August 30, 2022

Re: Updates to Proposed Deacon Hayes Commons, Parsonage/Walnut Hill Roads

Deacon Hayes Commons  
North Yarmouth, Maine

## Hydrogeologic Assessment of an Engineered System Deacon Hayes Commons Walnut Hill Road, North Yarmouth

**SEPTIC SYSTEM SECTIONS AND DETAILS**  
**DEACON HAYES COMMONS**  
521 WALNUT HILL ROAD - NORTH YARMOUTH MAINE  
PREPARED FOR  
**527 LLC**  
865 OAK HILL ROAD - NORTH YARMOUTH, ME

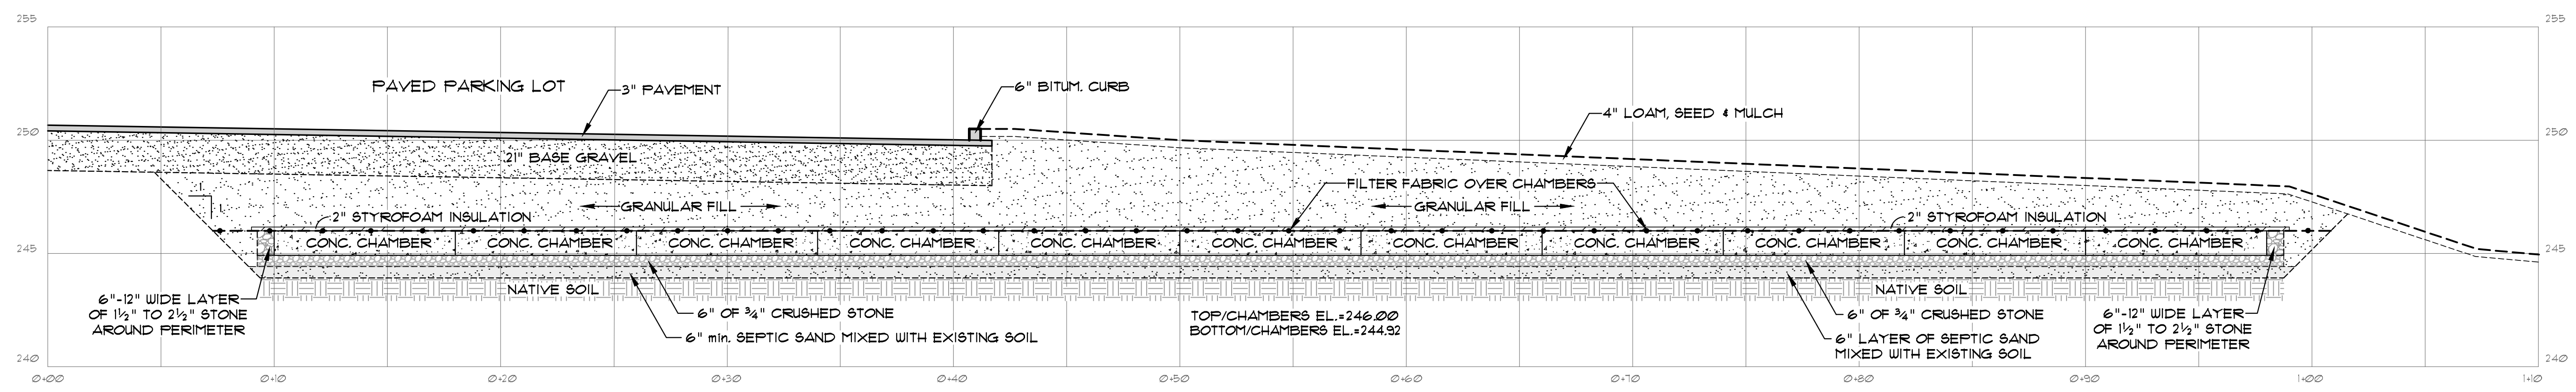
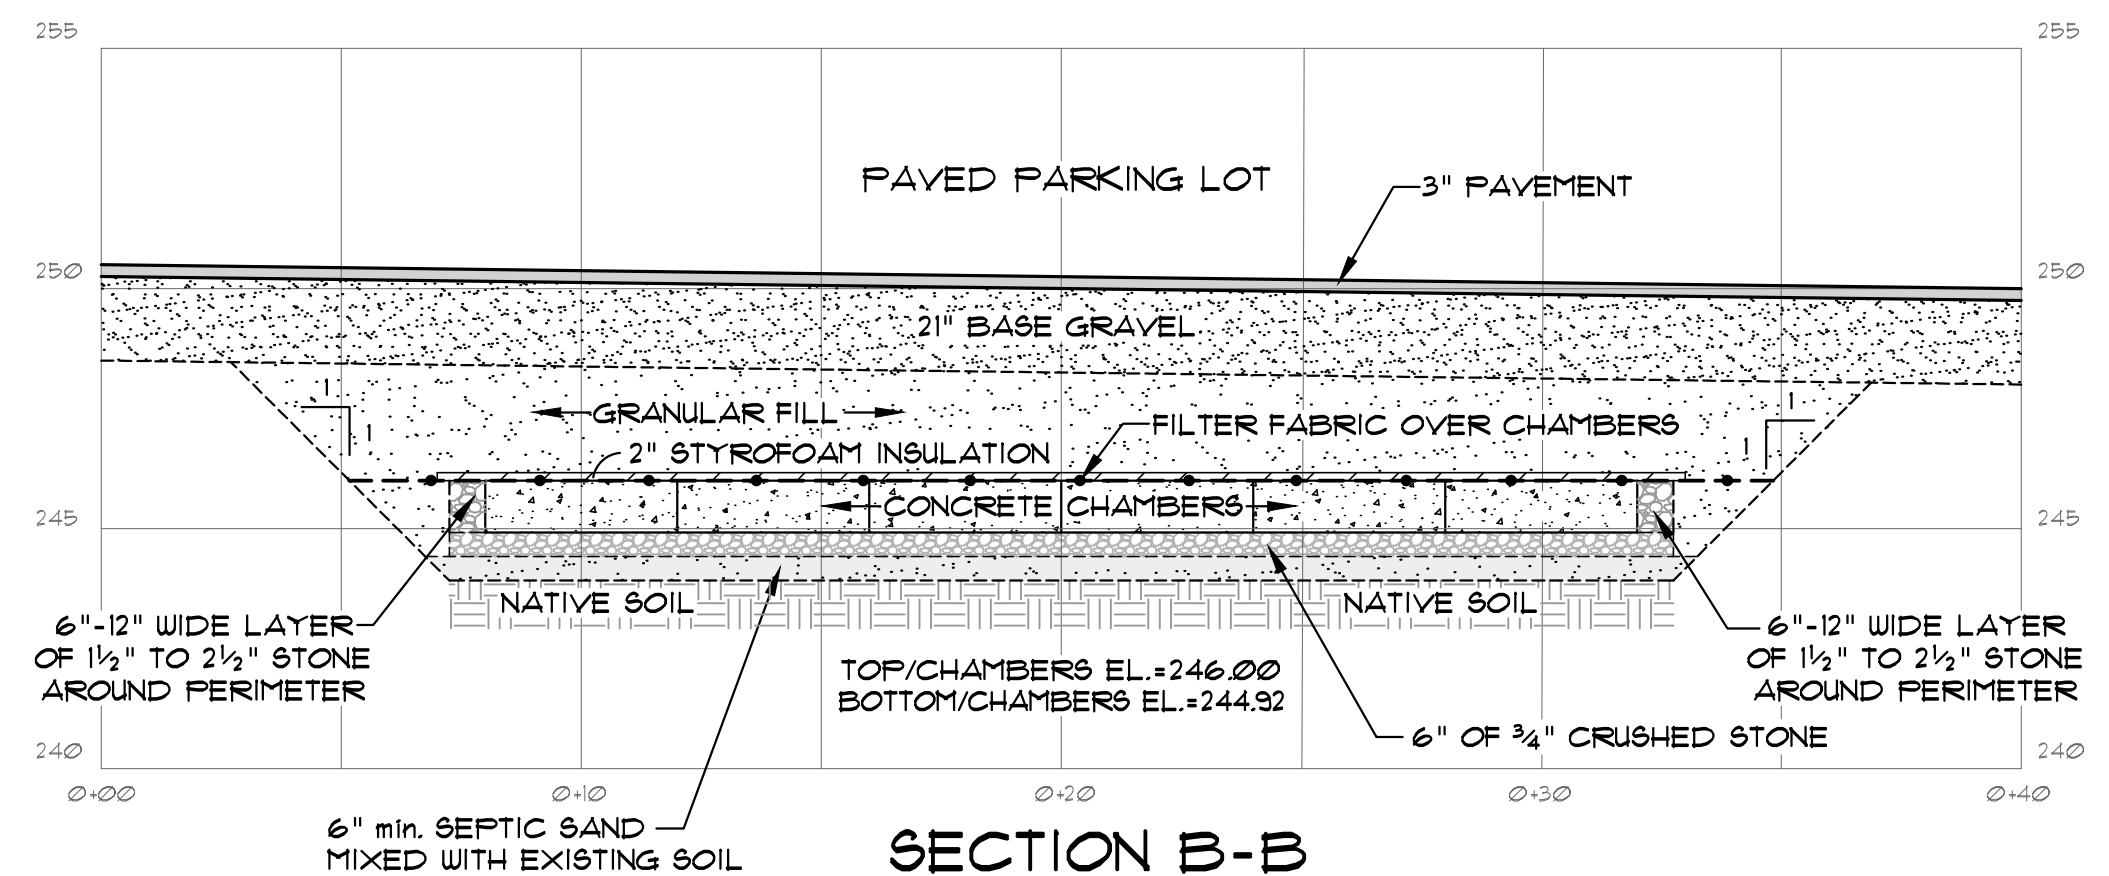
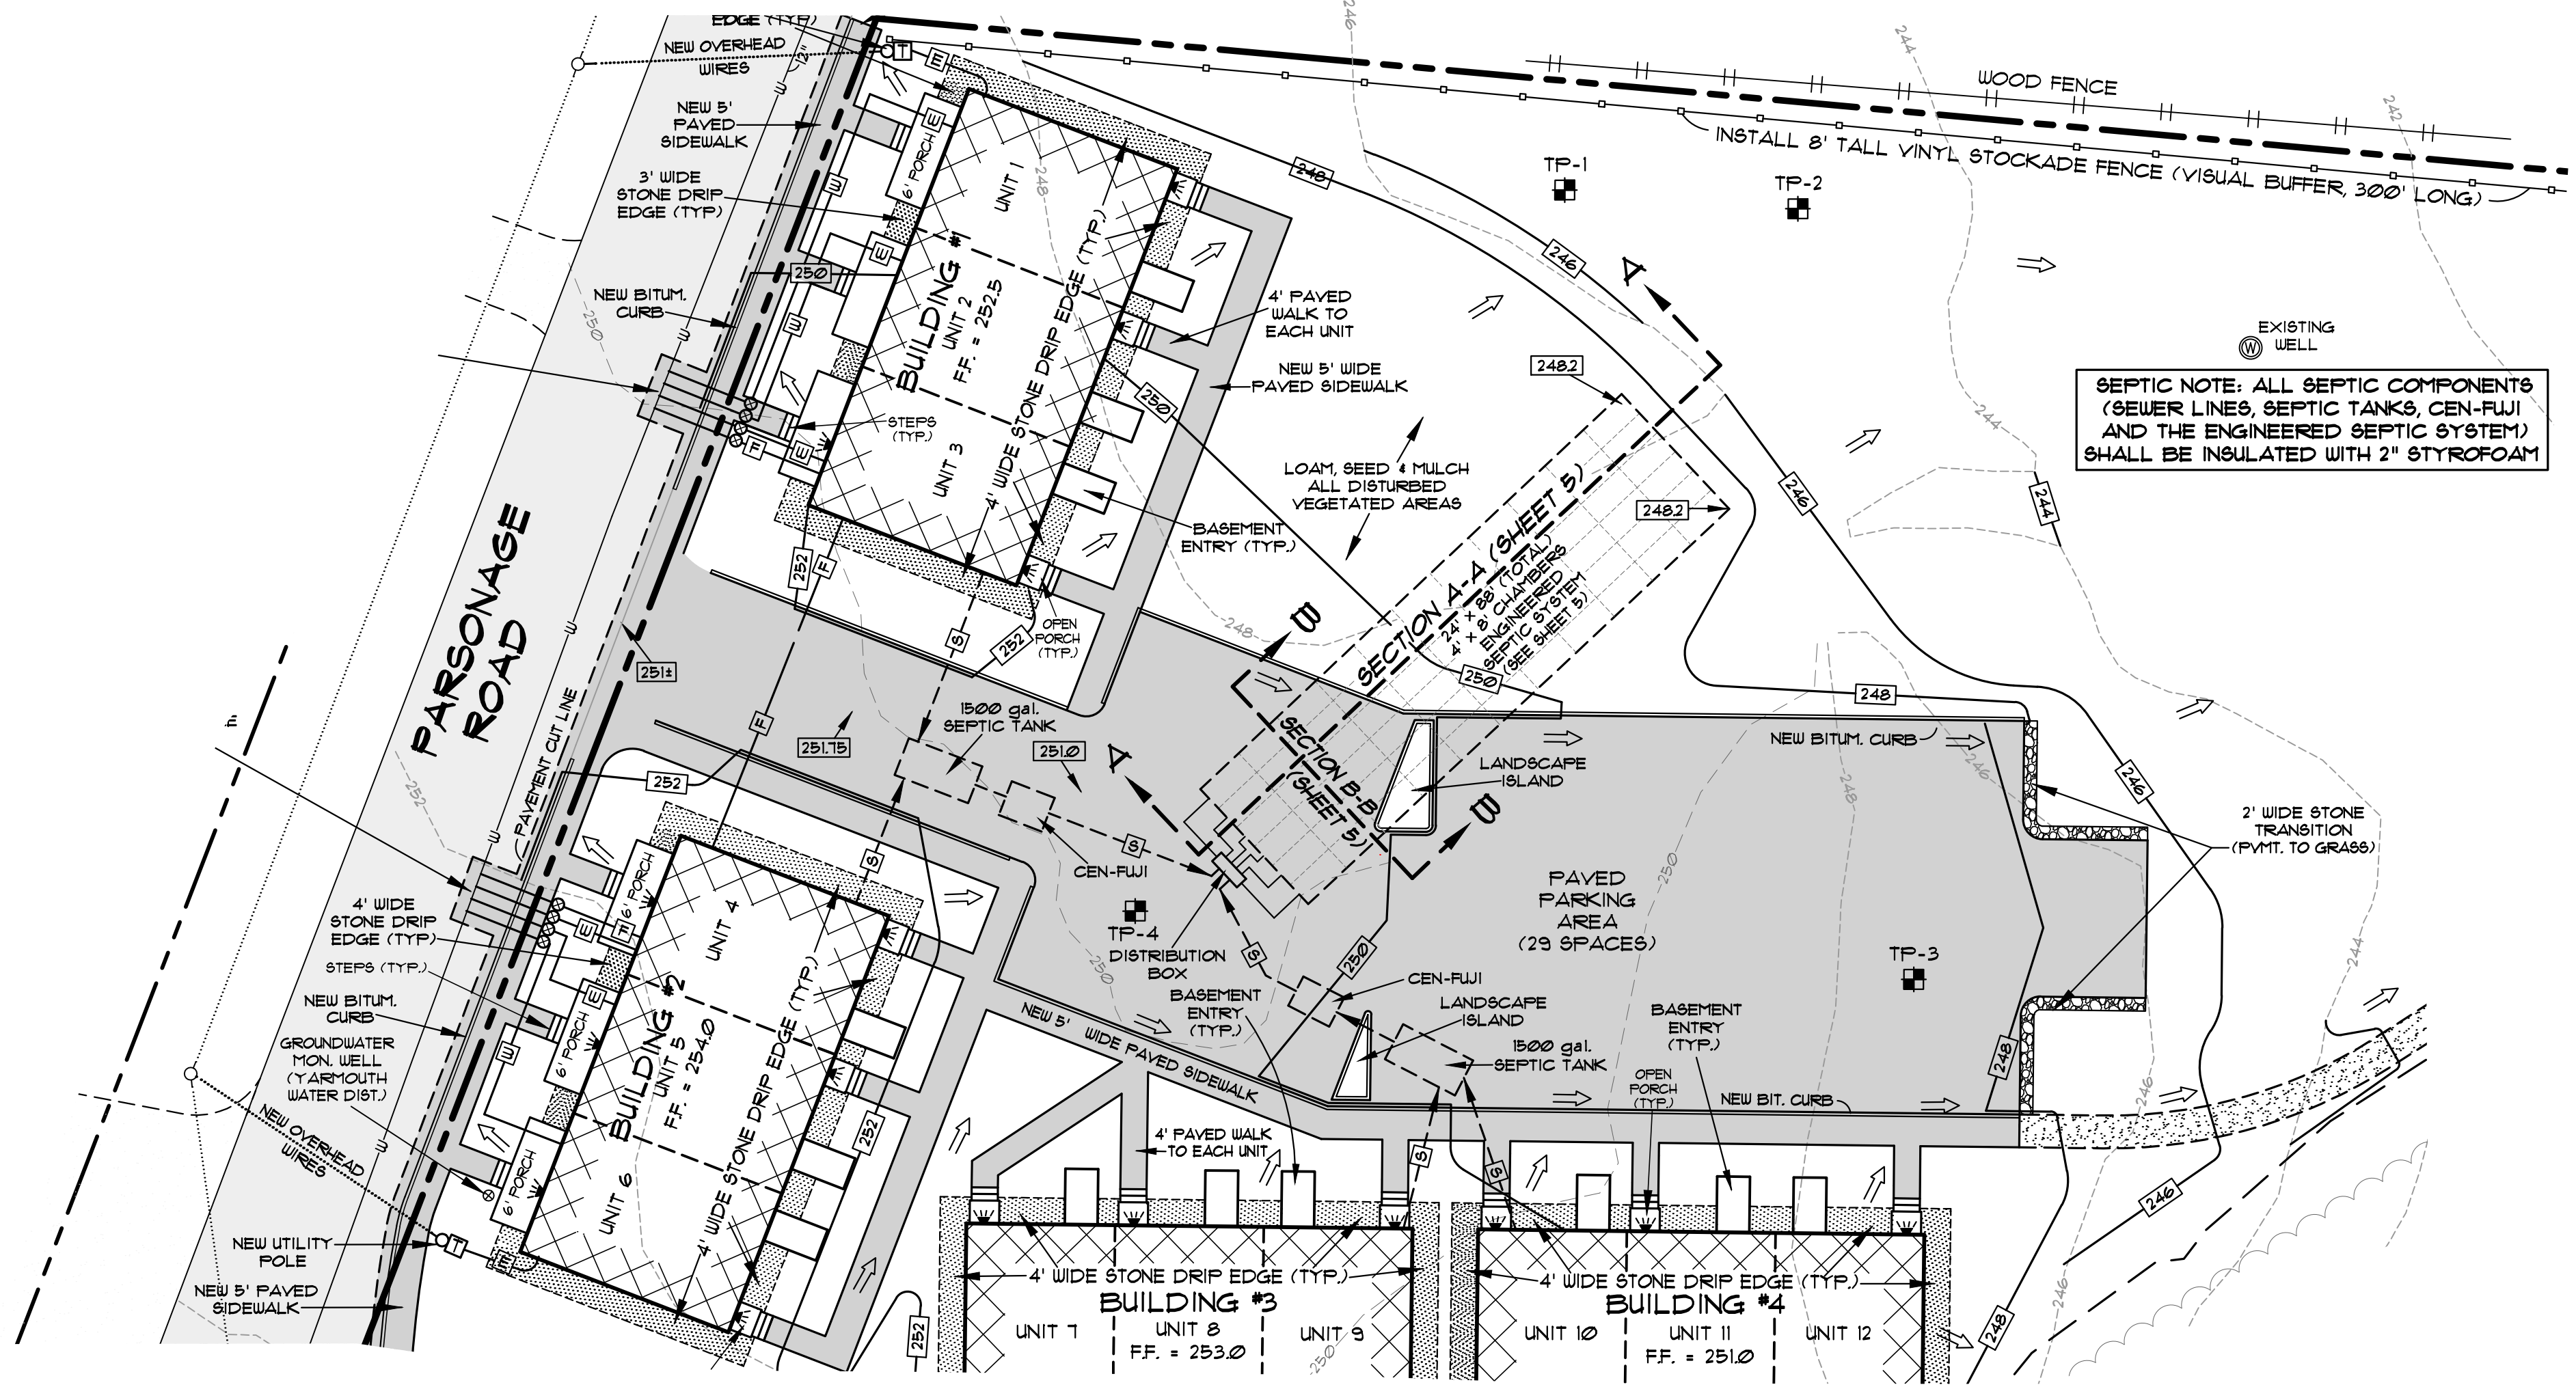
1. Design of a new engineered disposal system.
2. A revised groundwater nitrate study specific to the engineered disposal area meeting the Towns 5 mg/l nitrate level at the property line.
3. Relocated previously proposed landscaping planting away from the disposal system.
4. Updated the sidewalk along Walnut Street (location of proposed sidewalk was relocated further away from Walnut St. for safety and construction reasons).
5. Updates to the subdivision and site plan suitable for Planning Board signatures and recording in the registry.
6. Units 4, 8, and 11 are designated to be "Affordable Housing".

Therefore, a single, combined wastewater disposal area to be used by all residential units is proposed. This system will be more centrally located on the property and will use nitrogen removing aeration treatment technology. Because the design flow of this single system exceeds 2,000 gallons per day, the system is regulated as an Engineered System by the Division of Environmental Health of the State of Maine.

- 1) THE SYSTEM HAS BEEN DESIGNED TO ACCEPT RESIDENTIAL WASTES TYPICAL FOR A 3 BEDROOM UNIT. THE DESIGN HAS BEEN REVIEWED BY THE TOWN OF NORTH YARMOUTH PLUMBING INSPECTOR AND HEALTH ENGINEERING DEPARTMENT OF DEP. BOTH REVIEW AGENCIES NEED TO APPROVE THE SYSTEM PRIOR TO CONSTRUCTION.
